IMPORTANT SAFETY RECALL

Tiffin Recall # TIF-131

PowerGlide A/C Compressor Failure Causes Loss of Drive Power

IFM Chassis Controller needs repair

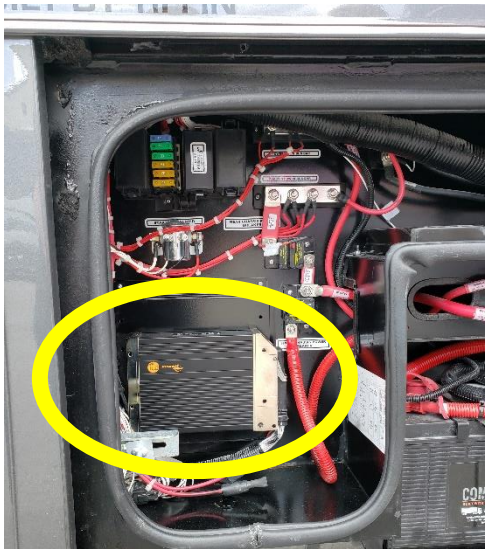
On certain motorhomes equipped with an IFM brand of chassis controller, in the event of an A/C compressor failure, the current draw spike from the compressor will blow the fuse protecting the circuit. This circuit also supplies power to the chassis ignition switch. In the event of an A/C compressor failure there would be a sudden loss of power to the chassis. If the chassis were to lose power, this would increase the risk of a crash.

Owners may verify the brand of chassis controller that is installed. During this time frame, Tiffin Motorhomes used 2 different chassis controllers. The chassis controller is located in the passenger side rear compartment. After

visually inspecting the chassis controller, if it is not an IFM brand, then repair is not required. Please email recalls@tiffinmotorhomes.com along with your VIN number that your motorhome does not have an IFM brand controller, and we will clear the recall from your motorhome.

Tiffin Motorhomes will have the brand of controller verified and, if an IFM brand of chassis controller is installed, a harness equipped with an inline fuse will be installed to protect the power to the ignition switch in the event of an A/C compressor failure.
